Public Service  
Company of Colorado

August 5, 1988  
Fort St. Vrain  
Unit No. 1  
P-88287

SUBJECT: Technical Specification  
Upgrade Program (TSUP)  
Revisions to Final Draft

As a result of a telephone conference with the NRC on July 13, 1988, the following changes have been made to the FSV TSUP draft submittals dated May 25, 1988 and June 13, 1988: (the asterisked margin marks distinguish the most recent revisions).

Figure 3.2.6-2

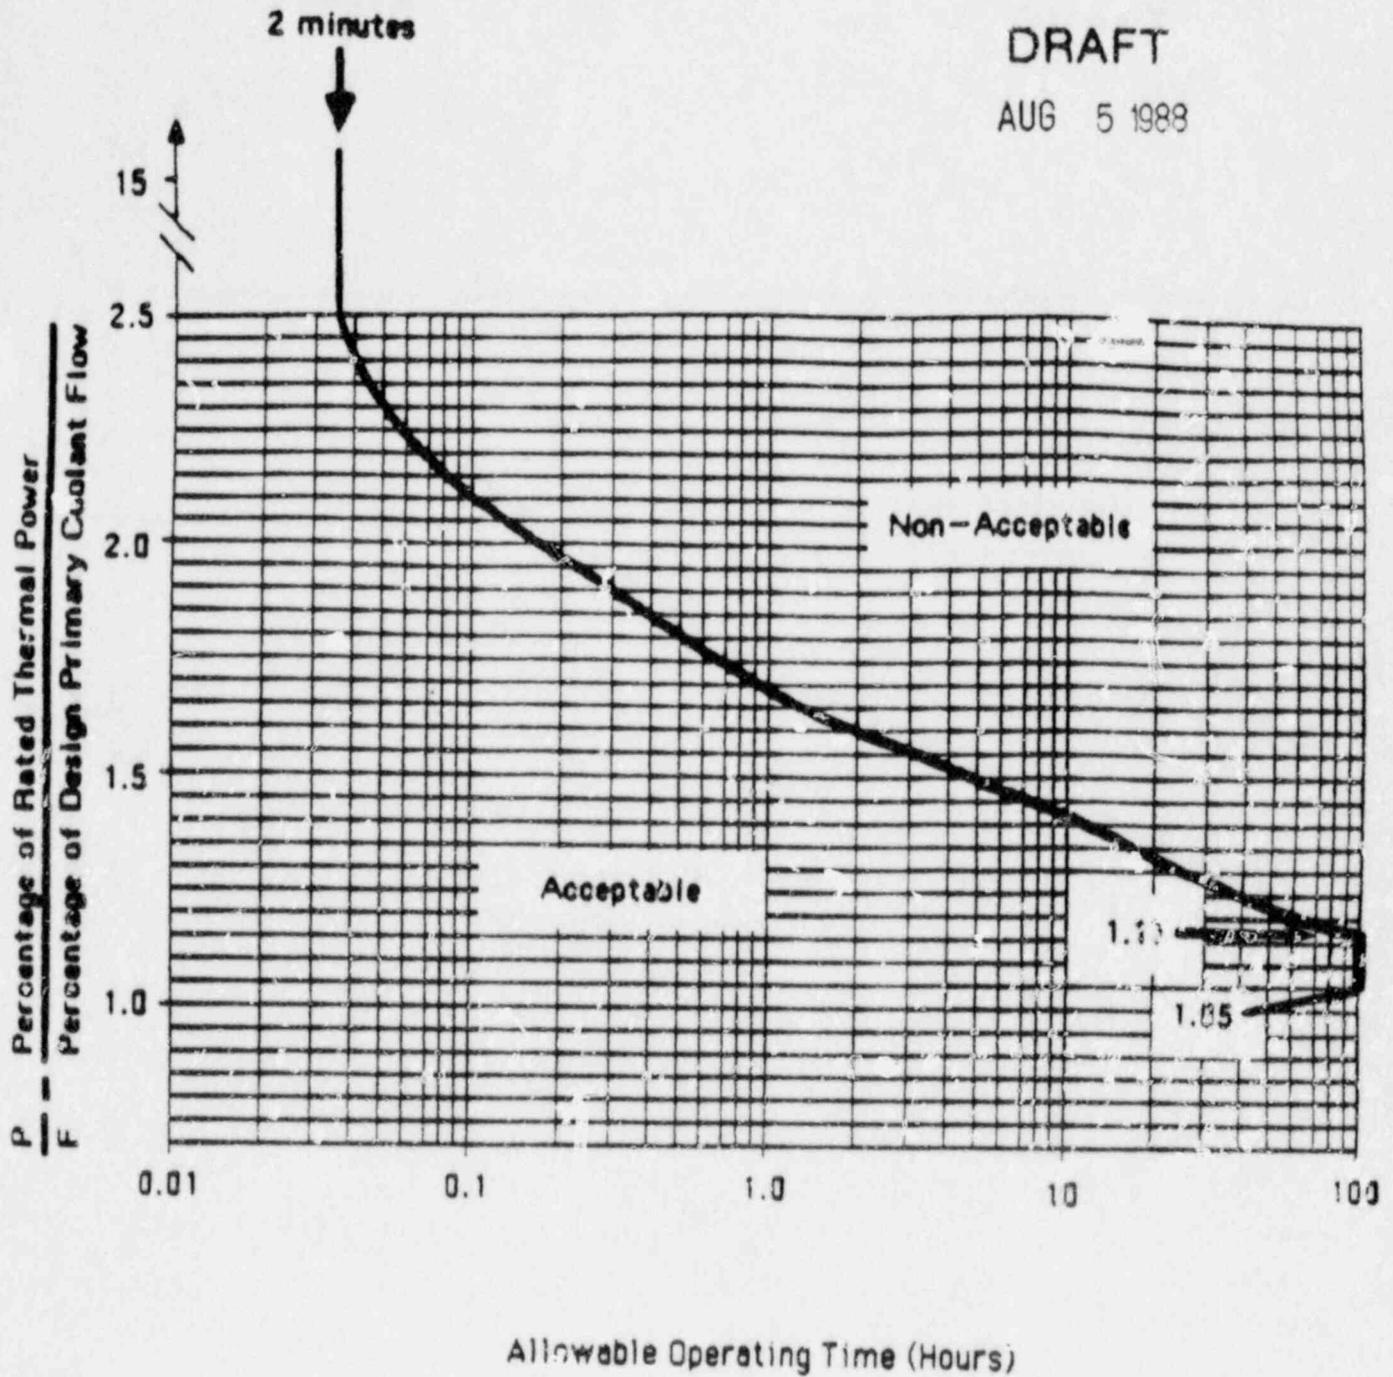
<u>Specification</u>	<u>Description of Change</u>
SL 2.1.1 BASIS	Editorial clarification; revised subparagraph #3 to indicate that actual time periods are determined for each P/F RATIO interval during which the limits are exceeded.
LCO 3.1.1, Action f	Added Action to declare control rod inoperable if slack cable alarm cannot be fixed within 24 hours, to avoid entry into Specification 3.0.3 and shutdown.
LCO 3.1.6 BASIS	Revised reserve shutdown system discussion to reflect maximum temperature defect.
LCO 3.2.6, Action c	Editorial clarification; revised to indicate that the fraction of allowable operating time is determined for each P/F RATIO interval experienced during the transient.
Figure 3.2.6-2	Revised to show 100 hour allowable operating time with P/F of 1.05 to 1.17, consistent with the requirements of current SL 3.1.3.4.
LCO 3.2.6 BASIS	Editorial clarification; revised consistent with the LCO.

c) P/F RATIOS Greater Than 15:

The fraction of Allowable Operating Time for this P/F RATIO interval experienced during each transient shall be that time period from the point where the P/F RATIO exceeds the limit of Figure 3.2.6-1, until it drops below 2.5, not including the first 60 seconds, divided by the Allowable Operating Time for this P/F RATIO interval (per Figure 3.2.6-2). The calculation of additional fractions for P/F RATIOS less than 2.5 are given in c.1.a above.
